Hearing Date: August 14, 2014
Case No.: **2013.0154E**
Project Name: **MOSCONE CENTER EXPANSION PROJECT**
Project Address: 747 Howard Street
Zoning: Downtown Commercial Support C-3-S
340-I Height and Bulk District
Block/Lot: 3723/115 and 3734/91
Project Sponsor: John Noguchi
Director of Convention Facilities Department
City and County of San Francisco
747 Howard Street, 5th Floor
San Francisco, CA 94103
Staff Contact: Elizabeth Purl – (415) 575-9028
Elizabeth.Purl@sfgov.org

DATE: July 30, 2014
TO: Members of the Planning Commission and Interested Parties
FROM: Sarah Jones, Environmental Review Officer
RE: **Attached Responses to Comments on Draft Environmental Impact Report Case No. 2013.0154E for the Moscone Center Expansion Project**

Planning Department Case No. 2013.0154E
State Clearinghouse No. 2014012050

Moscone Center Expansion Project 2013.0154E
Figure II-3 (REVISED)
 Proposed Site Plan

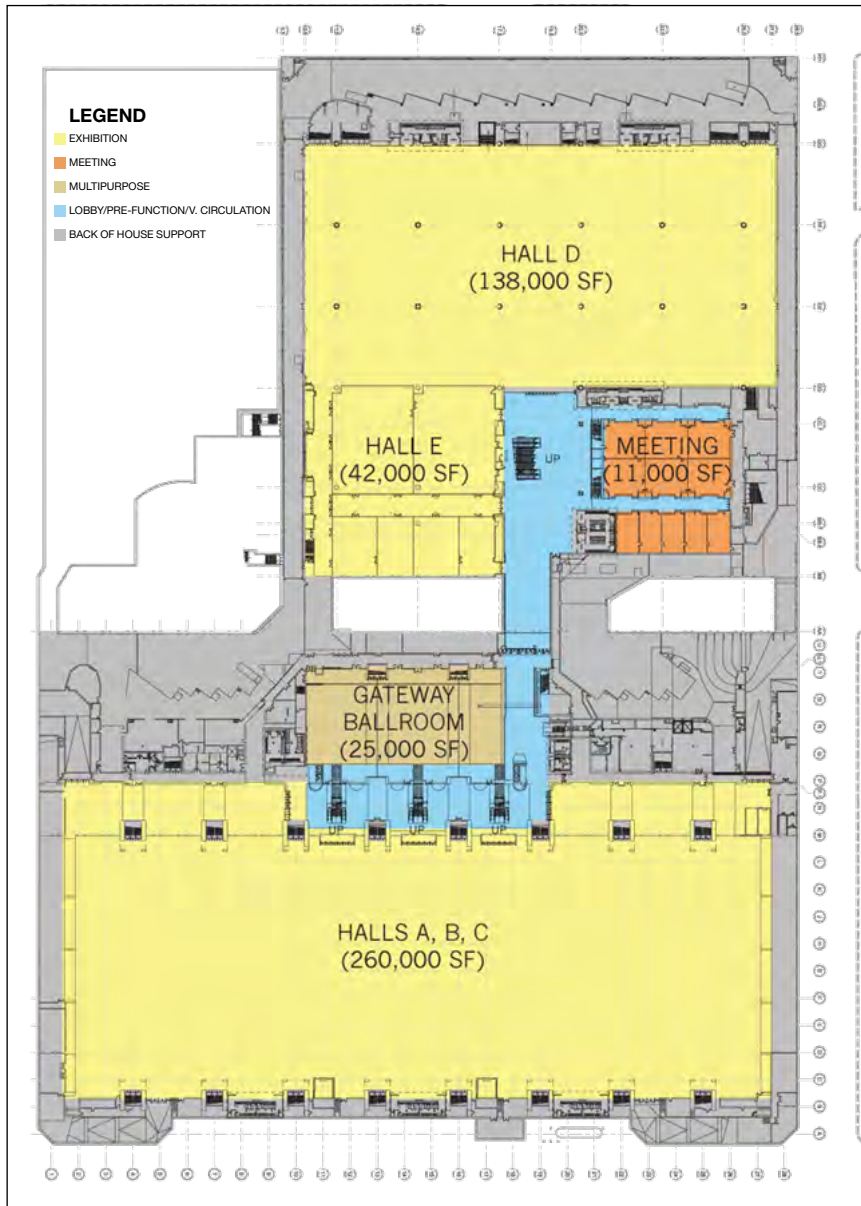
- Figure II-3 shows the revised rooftop of the Moscone South and Esplanade, the modified western pedestrian bridge, and the modified flexible open space around the carousel.

“In the final EIR can more information be included as to what exactly is happening with the Yerba Buena Garden and the Children’s Playground, (back to the graphics issue), it does not show the fountain in the proposed plan Figure II-3, page II-10, but does a good job in page VI-13 / Figure VI-1. We need to do as much as possible to keep these existing gardens intact.” (Dennis Hong, email, June 16, 2014)

The Martin Luther King Memorial Fountain is shown in Figure II-3 on page II-10. Please see the revised Figure II-3, which also shows the fountain, in Section V.III.E of this document. No changes to the fountain are proposed.

Moscone Center Expansion Project 2013.0154E
Figure II-4 (REVISED)
Existing and Proposed Lower Level Plan

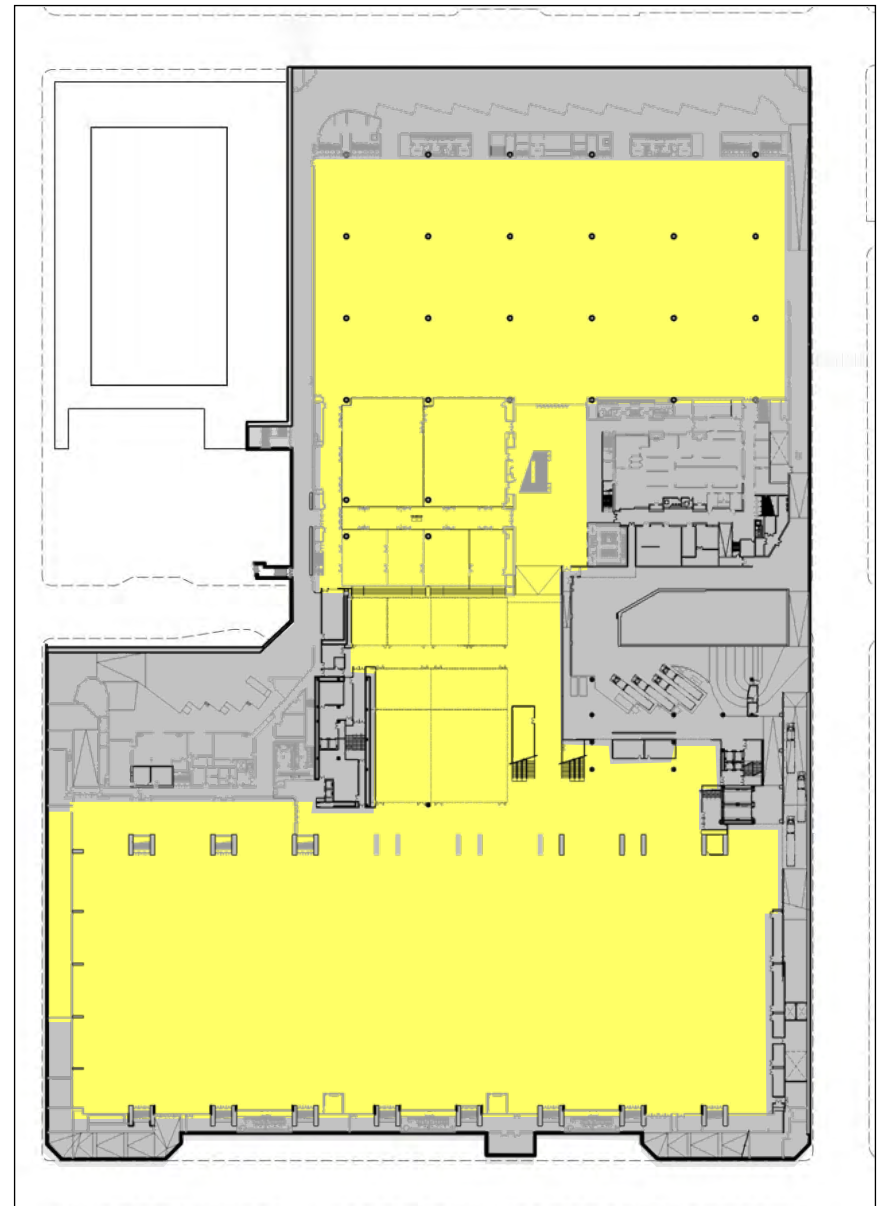
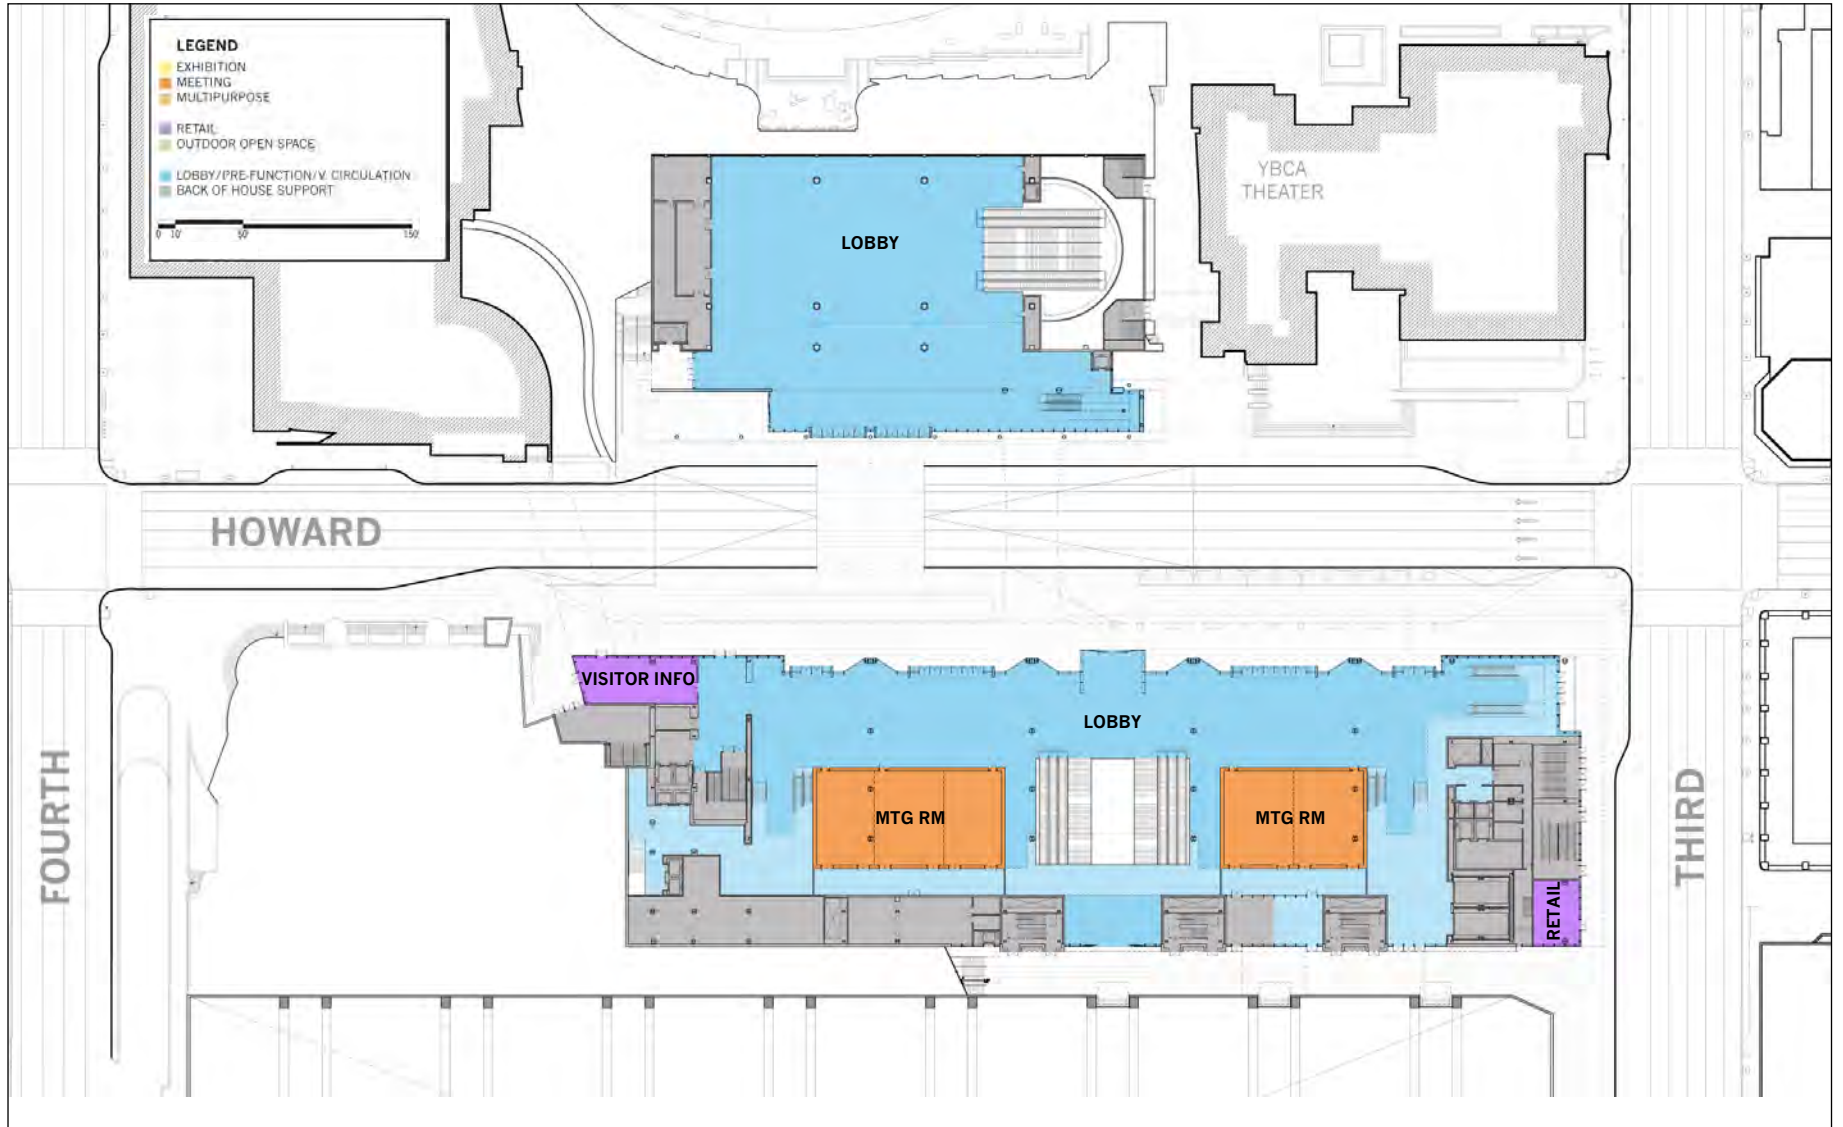
- Figure II-4 now includes the footprint of the project blocks, as well as the lower level's relation to the Metreon building to the west, to better orient the lower level plan within the existing project blocks. The figure now also includes a legend.

Figure II-6 (REVISED)
Proposed Mezzanine Plan

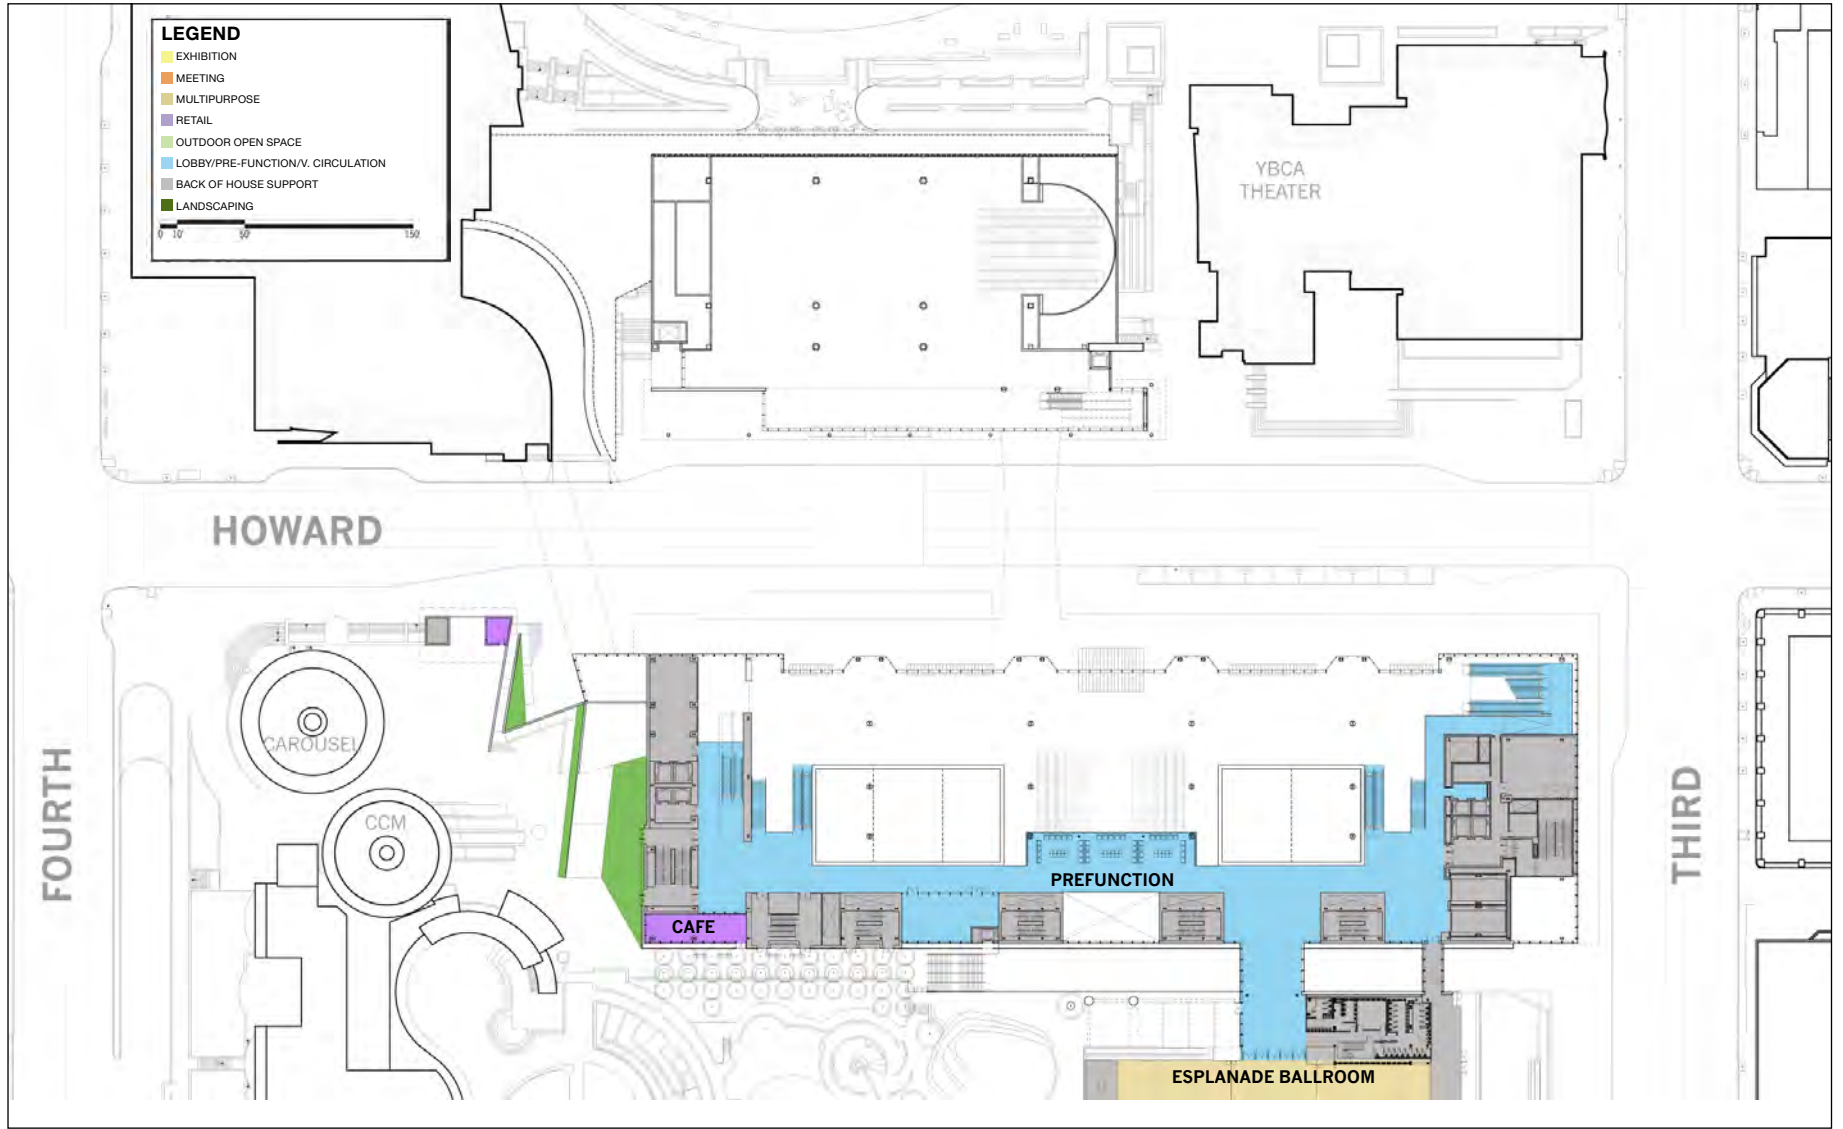
- Figure II-5 shows the revised floor plan for the Moscone South/Esplanade, Level 1.
- Figure II-6 shows the revised floor plan for the Moscone South/Esplanade, Mezzanine Level, as well as revisions to the flexible open space at the western pedestrian bridge landing in the Children's Garden.

Figure II-7 (REVISED)
Proposed Level 2 Plan

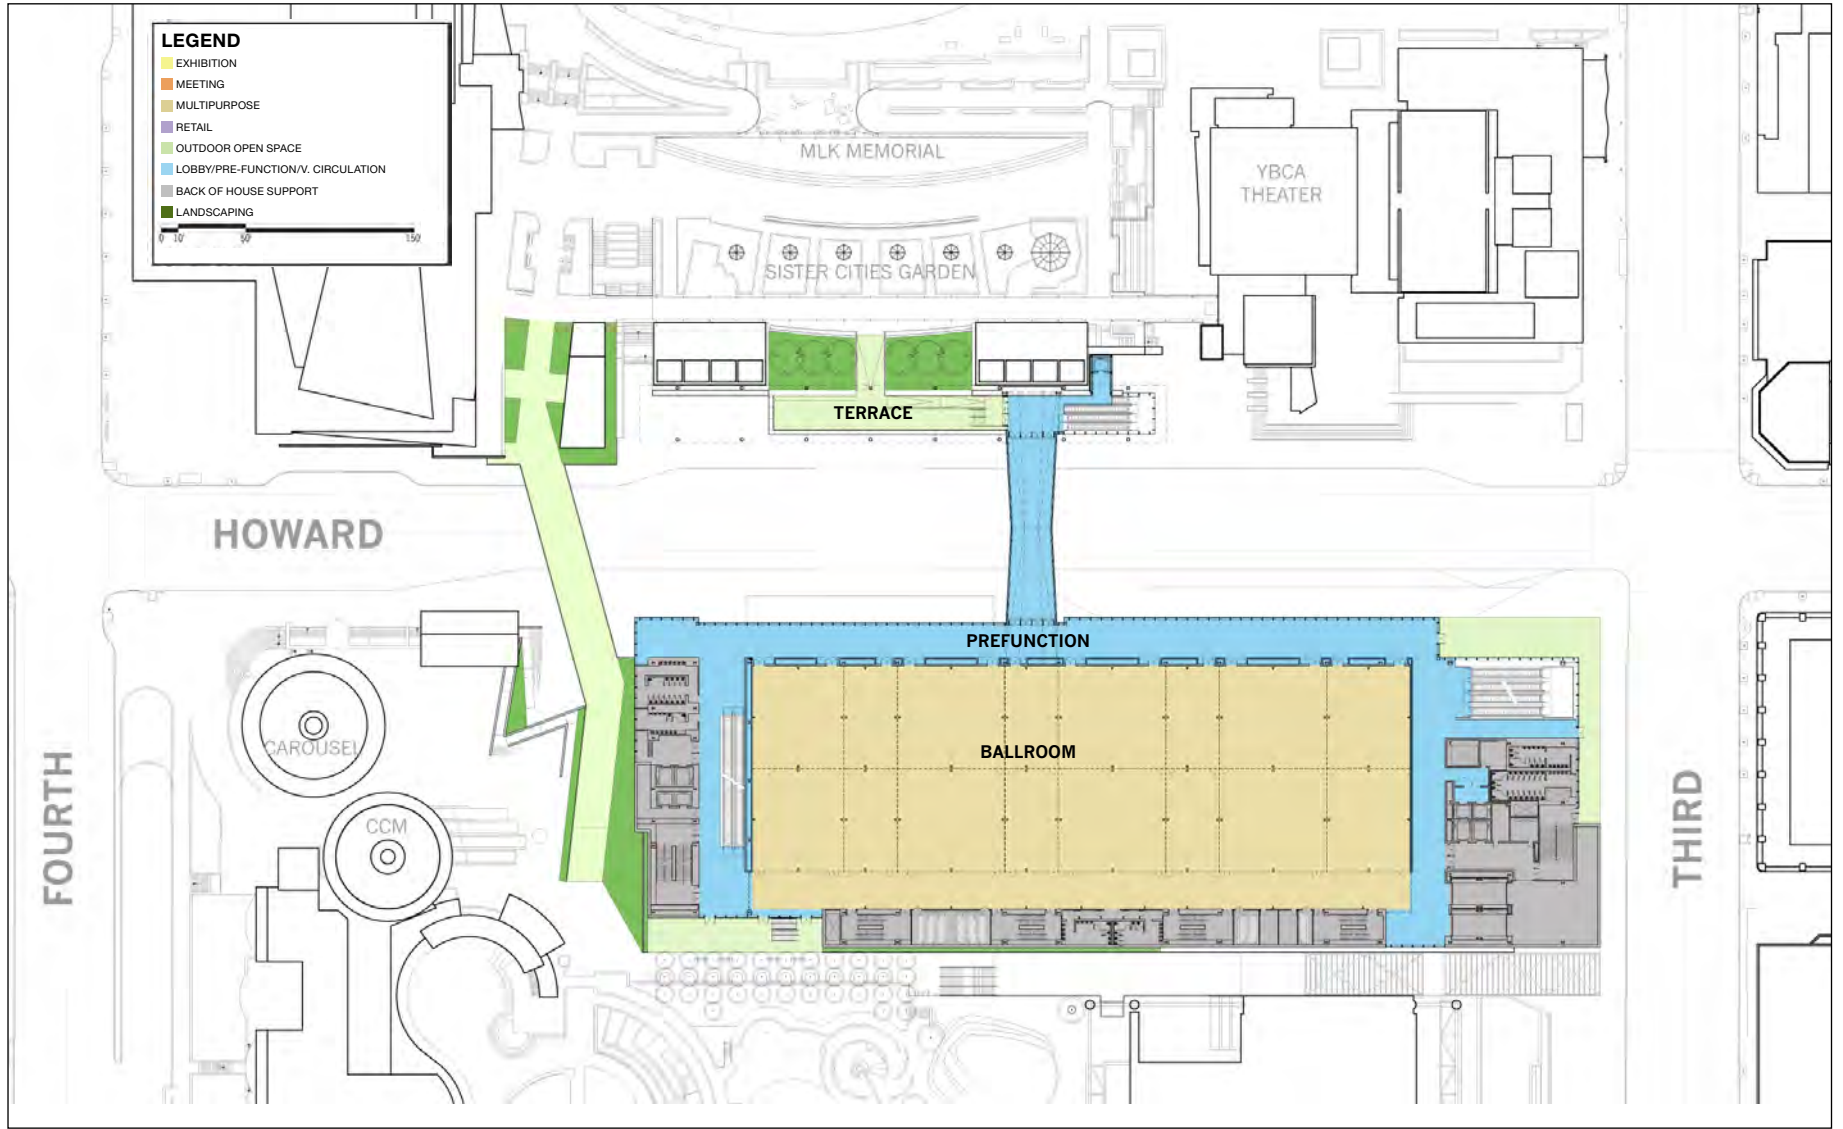
- Figure II-7 presents the modified western pedestrian bridge and landing in the Children's Garden.
- Figure II-8 shows the revised floor plan for the Moscone South/Esplanade, Level 3, specifically presenting the larger terrace adjacent to the Children's Garden.

Moscone Center Expansion Project 2013.0154E
Figure II-9 (REVISED)
Section Through North and South Lobby Buildings Looking East

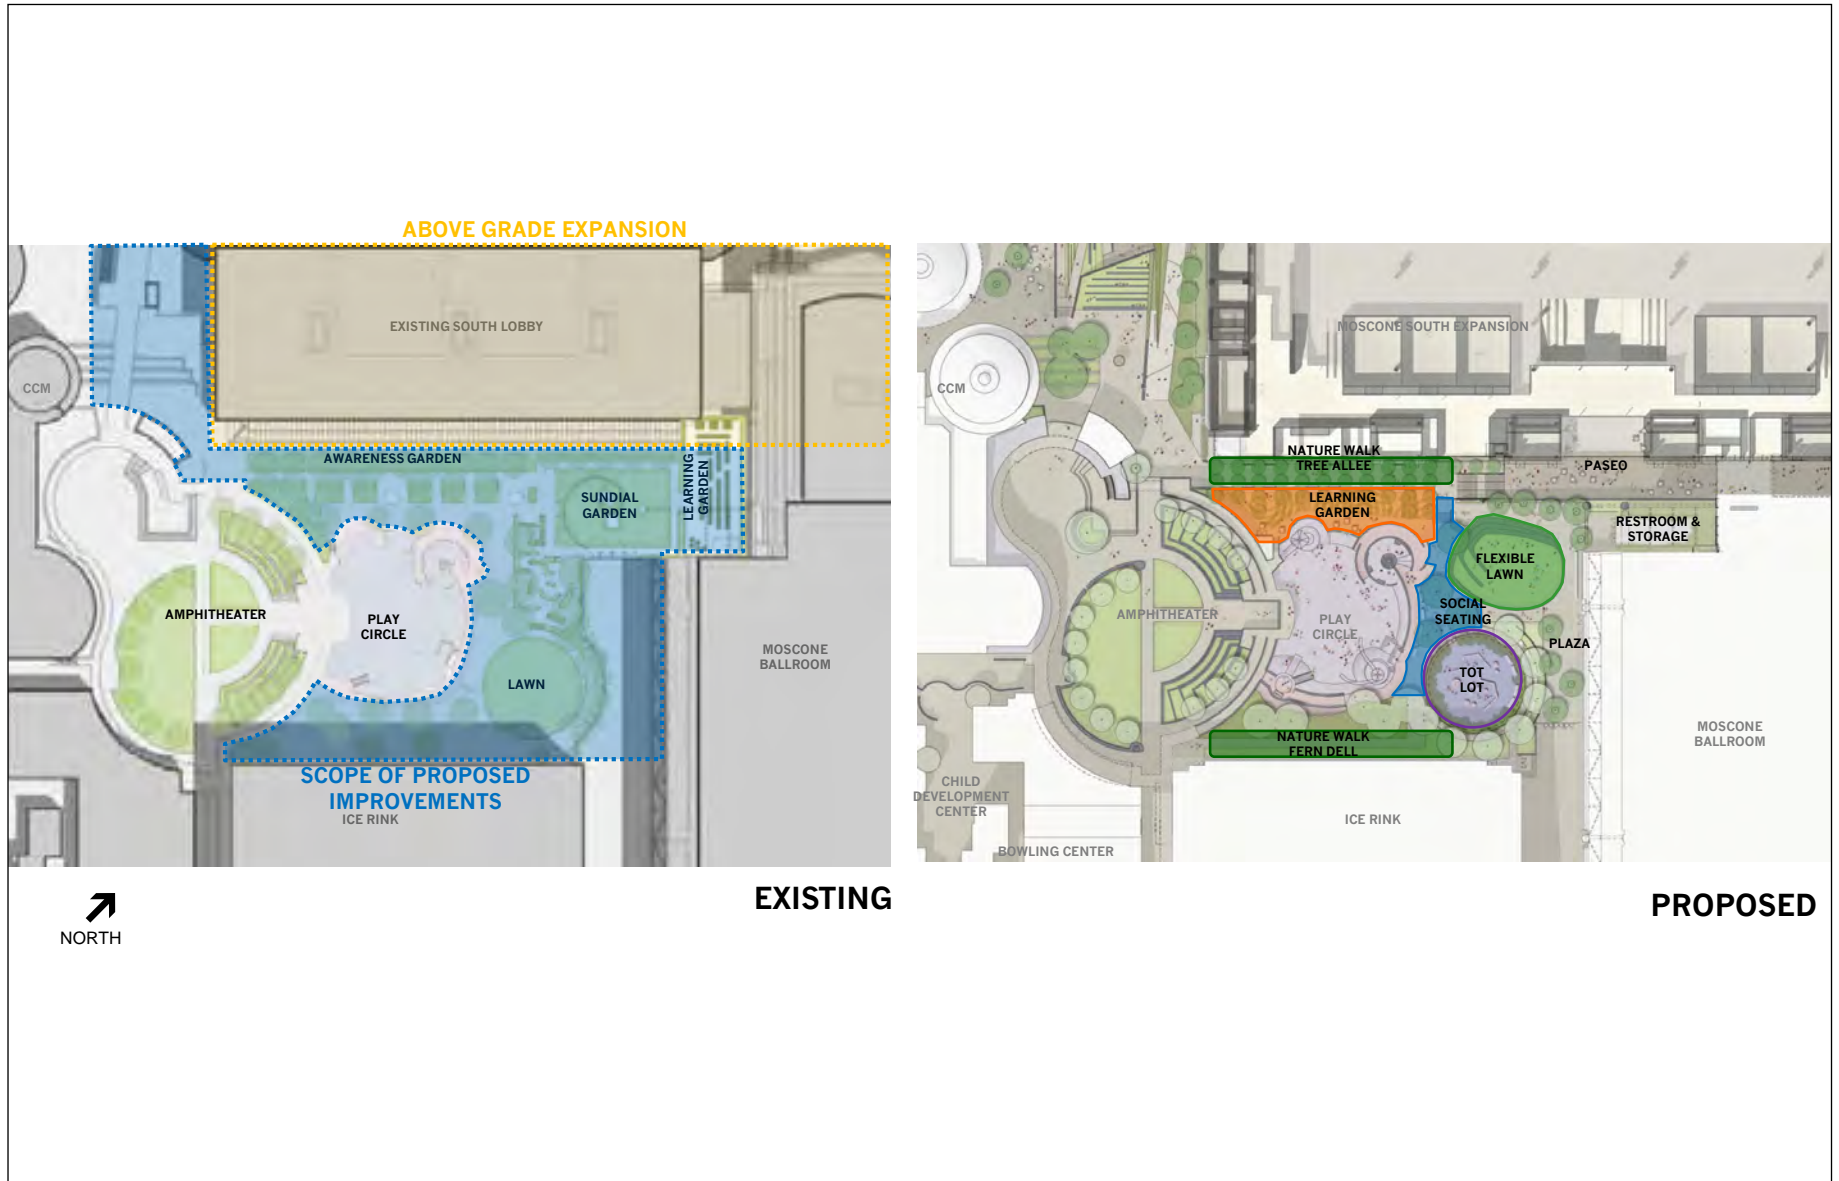
- Figure II-9 shows the revised cross-section of the project, which includes the larger Level 3 terrace facing the Children's Garden.
- Figure II-10a presents revisions to the improvements proposed for the Children's Garden.
